621 King Street West - Zoning Amendment Application - Refusal Report

Date:	December 12, 2011
To:	Toronto and East York Community Council
From:	Director, Community Planning, Toronto and East York District
Wards:	Ward 20 – Trinity-Spadina
Reference Number:	11 242716 STE 20 OZ

Attachment 4: North Elevation

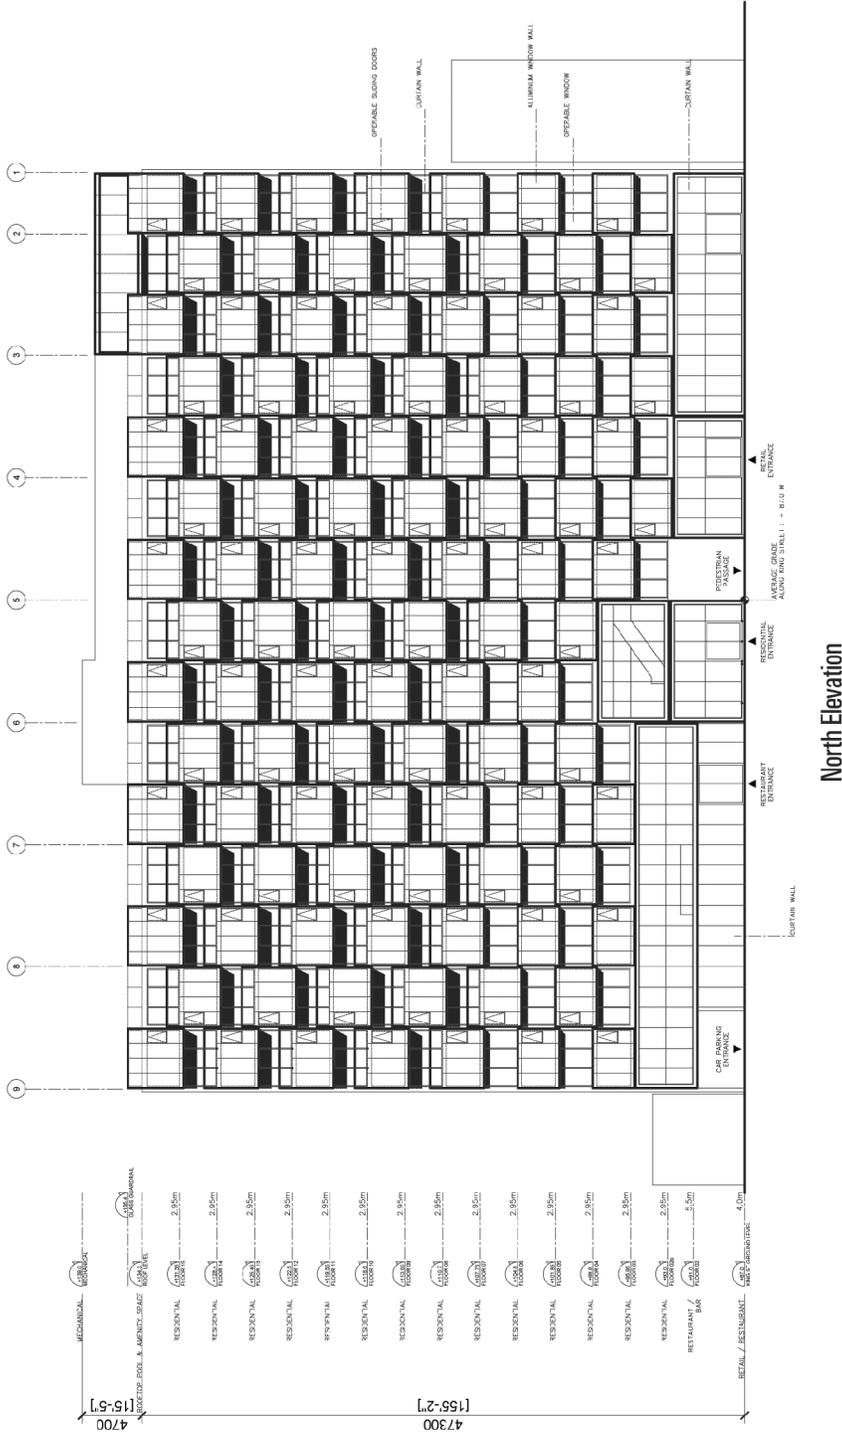
The project as proposed would result in a building on King Street West with a height at the street line of 47.3 metres (notwithstanding a 1.5 metre stepback at the third floor) versus the 20 metres as required by the By-law. The 34.7 metre building proposed for the Stewart Street frontage (with no stepback) is subject to the same required stepback at the streetline. King Street West between Bathurst Street and Brant Street is characterised by buildings at 2 to 4 storeys in height. New developments which have been approved with overall heights in excess of 20 metres provide for significant stepbacks from the street for height beyond that permitted in the Zoning By-law in recognition of the prevailing historic built form. Most of these recent approvals have been granted permissions for height based on the depth of the lots (taller portions have been stepped back from King

The proposed King Street building has a step back of 1.2 metres above the second storey. The façade of the building is described as having "a modular and rhythmic building face (streetwall) that articulates (popping in and out), vertically and horizontally, with alternating 1.2 and 2.7 metres setbacks above grade". This rhythm of alternately inset and protruding façade's for the 8th to 15th floors (floors 2 to 7 have a more modest 0.5 metre alternating setbacks) will not result in any reduction in the visible mass of the building, as it will not be apparent when looking at the building from the front, and when viewed from any angle, the more forward or protruding element will define the viewers perception of the building.

The proposed buildings should provide an appropriate setback at 20 metres to respect the historic built form in a manner similar to recently approved developments.

A 44 degree angular plane as required by the By-law at 20 metres in height measured at the street line would permit a building with height and massing which would allow for sunlight on the north sidewalk of King Street West at the critical lunch period and throughout the afternoon. The proposed building would not allow sunlight on the north sidewalk over the lunch period for much of the year.

Attachment 6: West Elevation

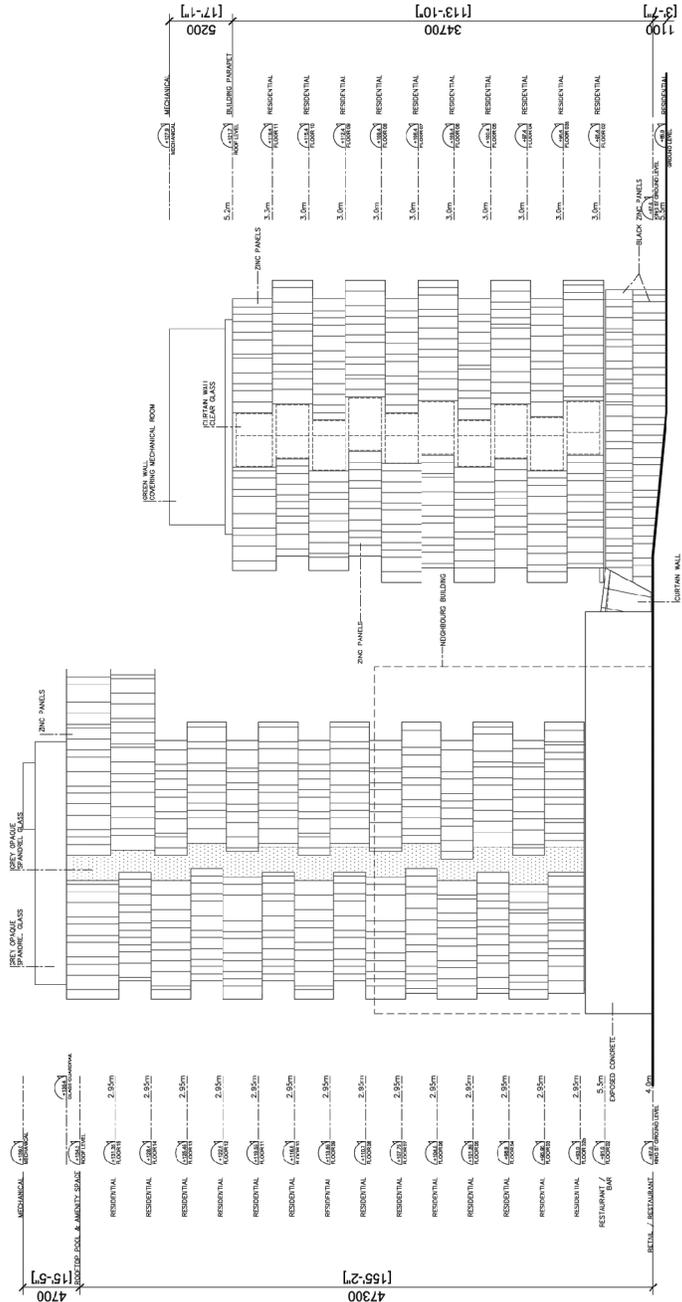
As discussed above, the proposed buildings do not address the width of the adjacent streets. A 1:1 relationship with adjacent streets is typically what defines an appropriate height for a building (or a podium or base building where a tall building is appropriate). In the case of the proposed buildings, tall buildings are not appropriate (the West Precinct of King-Spadina is a mid-rise neighbourhood) and there is little attempt at a base building for the King Street building and no attempt to create a base for the Stewart Street building.

City Planning staff also have concerns regarding the separation distances between the proposed 15 to 16-storey and 11-storey portions of the buildings. The applicants proposal would result in a "facing distance" between the proposed buildings of between 13 and 14 metres (based upon the varied articulation in the building design which has units alternately setback or projecting). There are several consequences to constructing buildings too close together, including resulting wind conditions, sense of pedestrian scale, lack of access to sunlight, loss of privacy and blockage of sky views. A minimum 15 metre separation between the King Street and Stewart Street buildings is recommended.
